**PP201/2012-3**

**15 Karingal Drive WYE RIVER**

**Construction of a Single Dwelling & Removal  
of Two (2) Trees**

# Application to AMEND a Planning Permit

**proposed dwelling**  
 15 Karingal Drive, Wye River  
 town planning  
**B. Pursehouse**

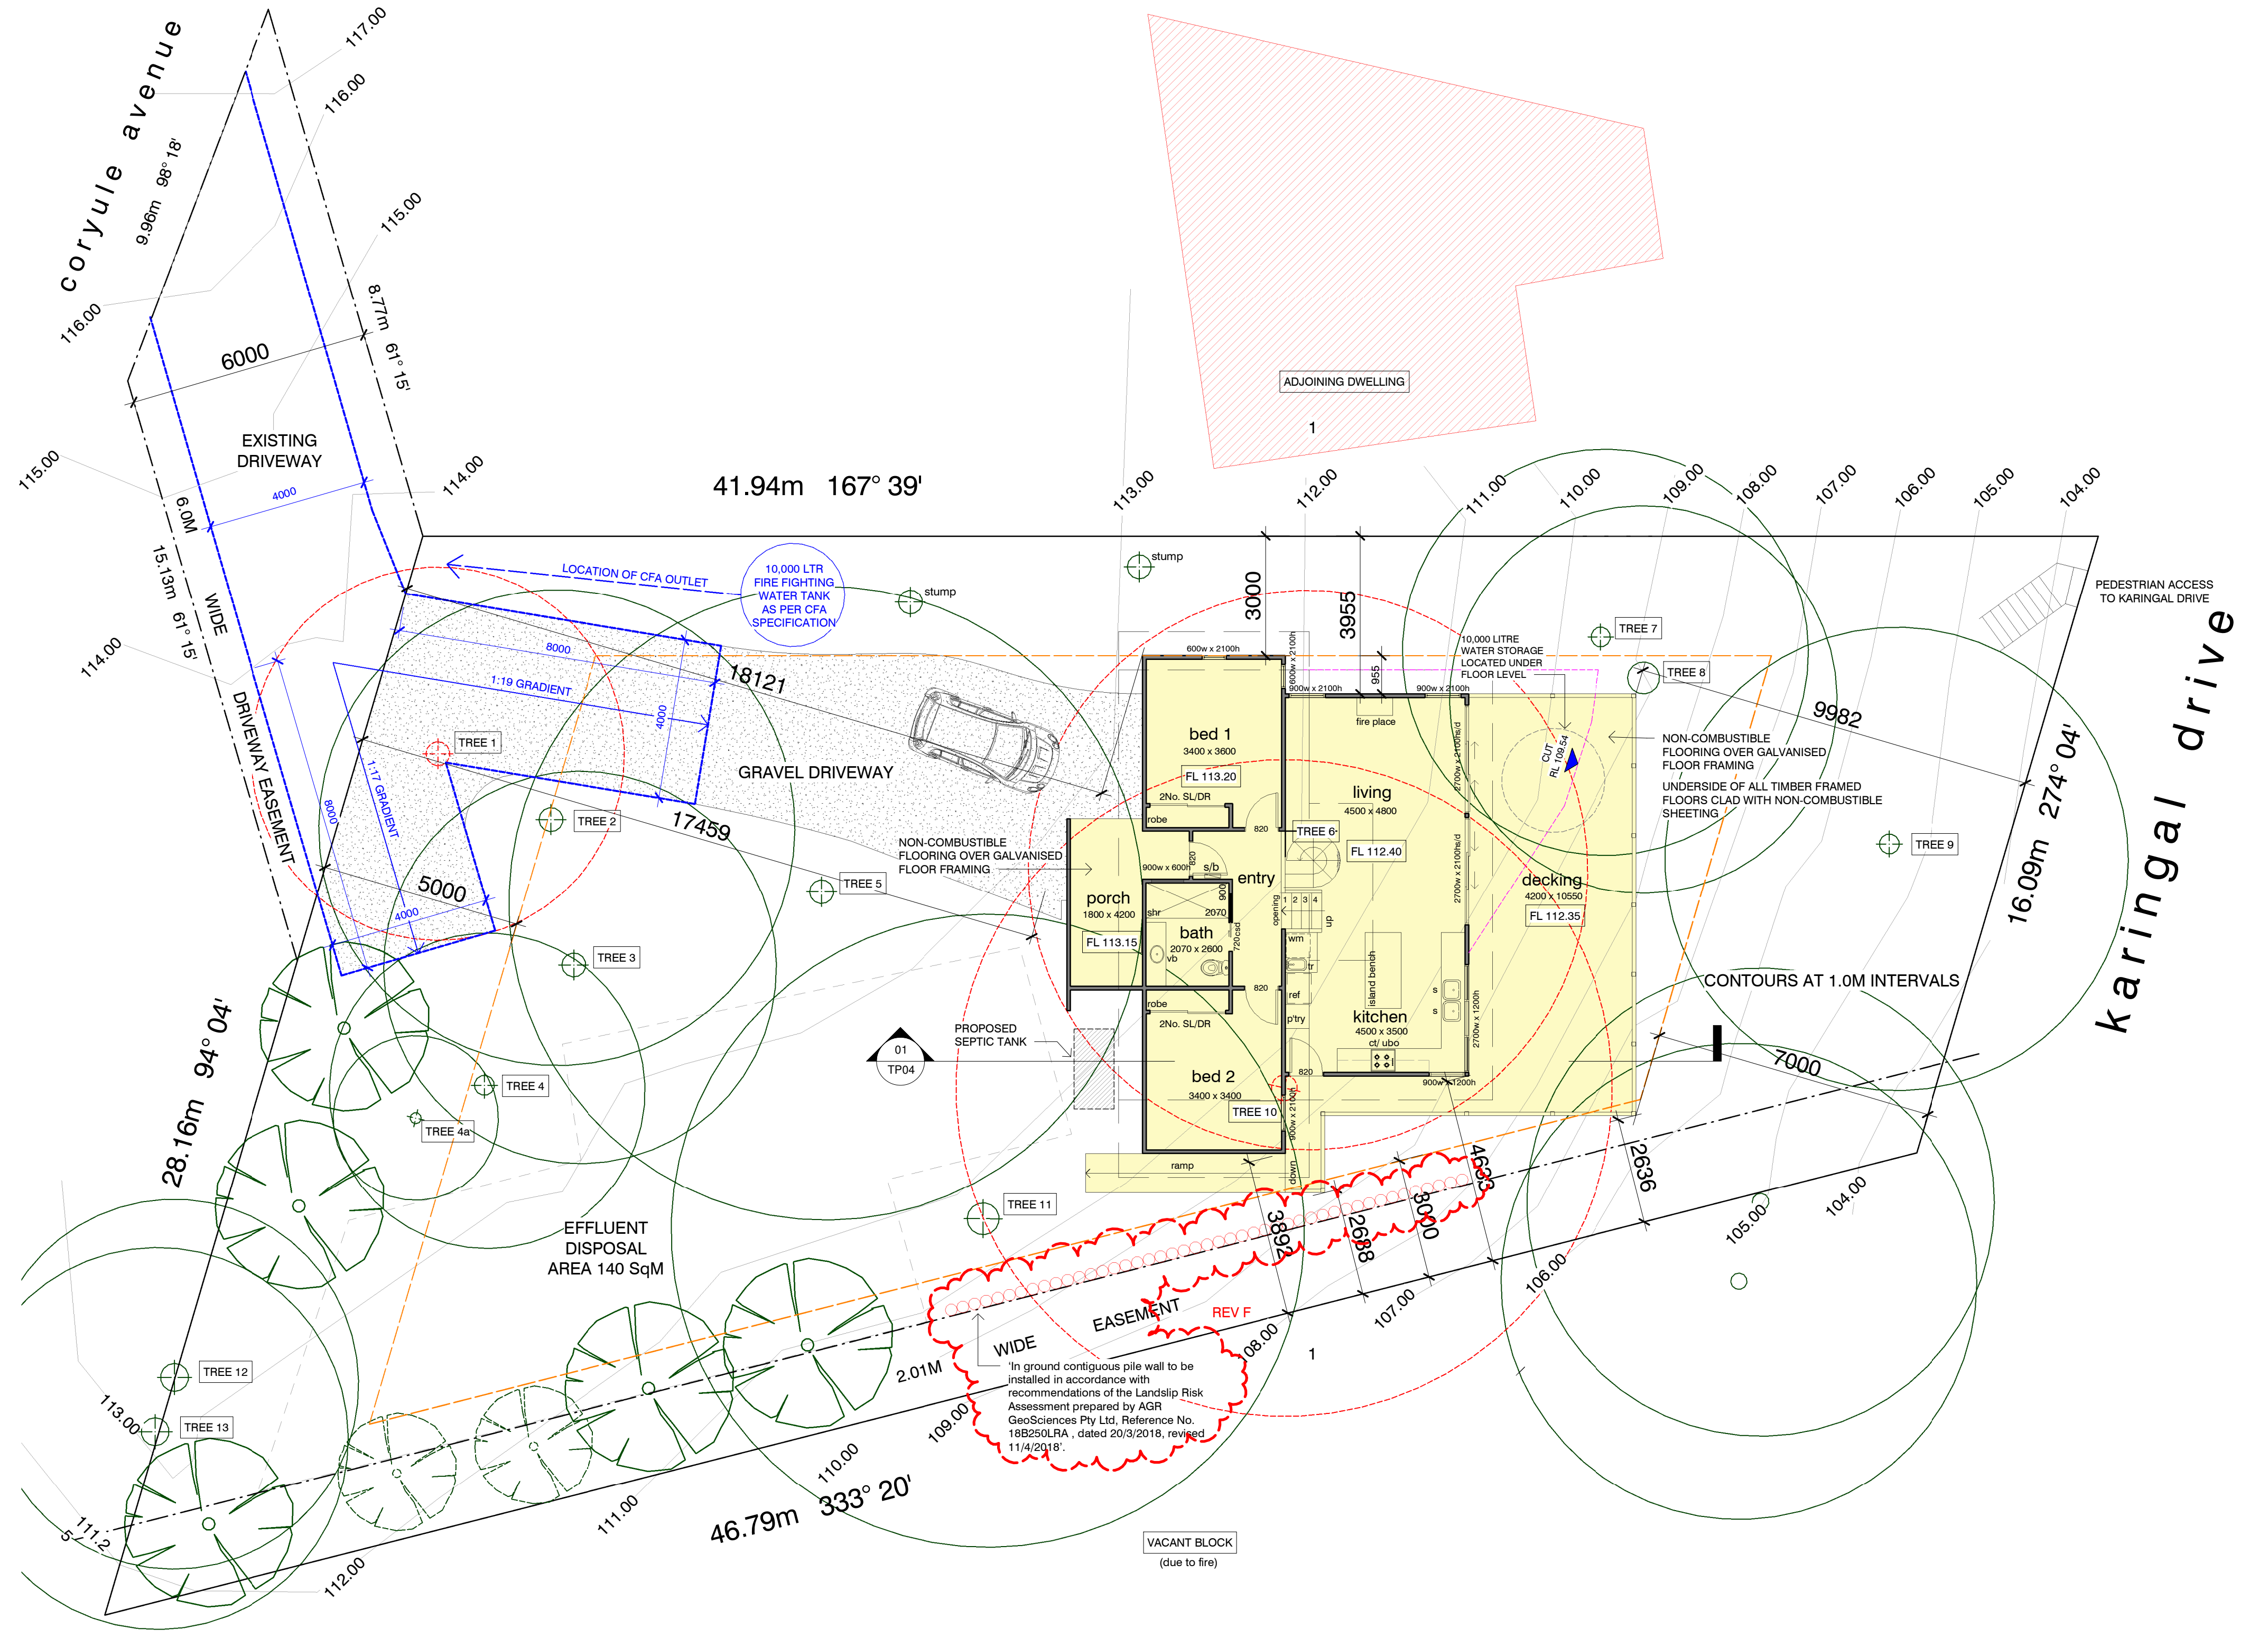
Rev G: Add First Floor 25.01.19  
 Rev F: TP F1 07.05.18 Council Change  
 Rev E: TP F1 04.05.18 Council Change  
 Rev D: TP F1 02.05.18 Council Change  
 revision C: TP F1 17.04.18 Bath Layout Change  
 revision/Rev B: TP F1 21.03.18

site plan - first floor

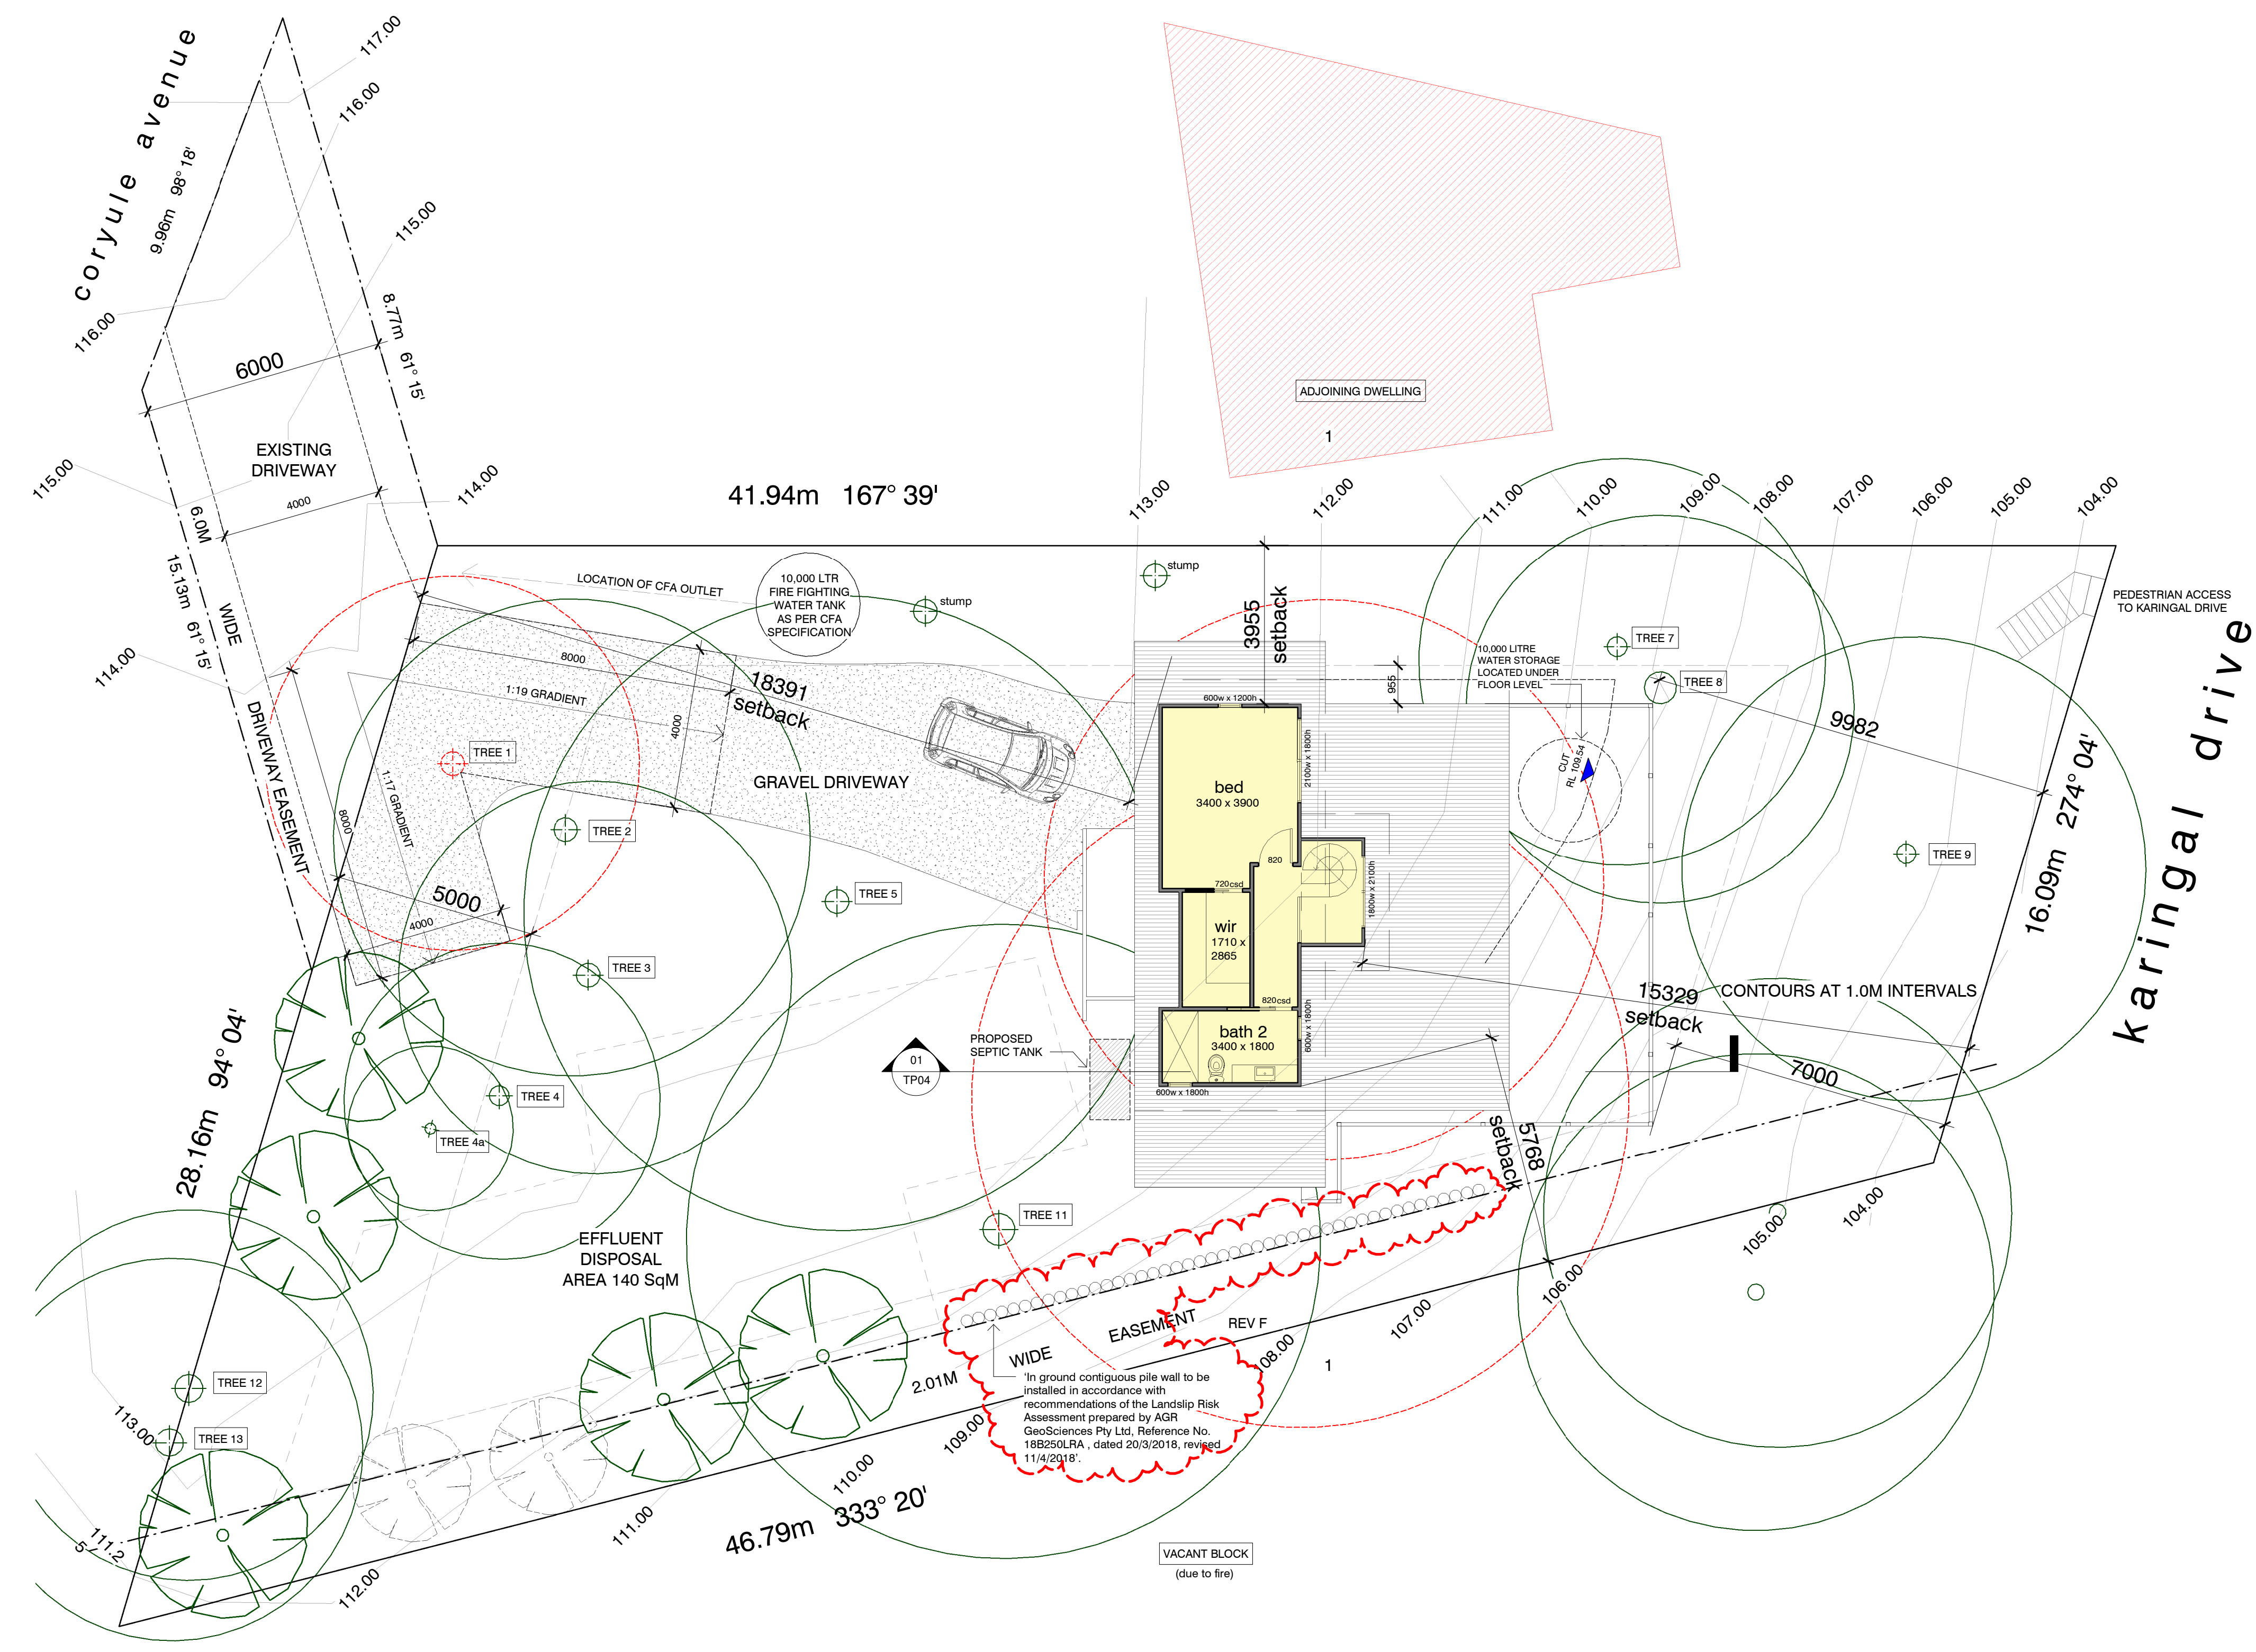
Rev G: Add First Floor 25.01.19  
Rev F: TP F1 07.05.18 Council Change  
Rev E: TP F1 04.05.18 Council Change  
Rev D: TP F1 02.05.18 Council Change  
Rev C: TP F1 17.04.18 Bath Layout Change  
revision: Rev B: TP F1 21.03.18
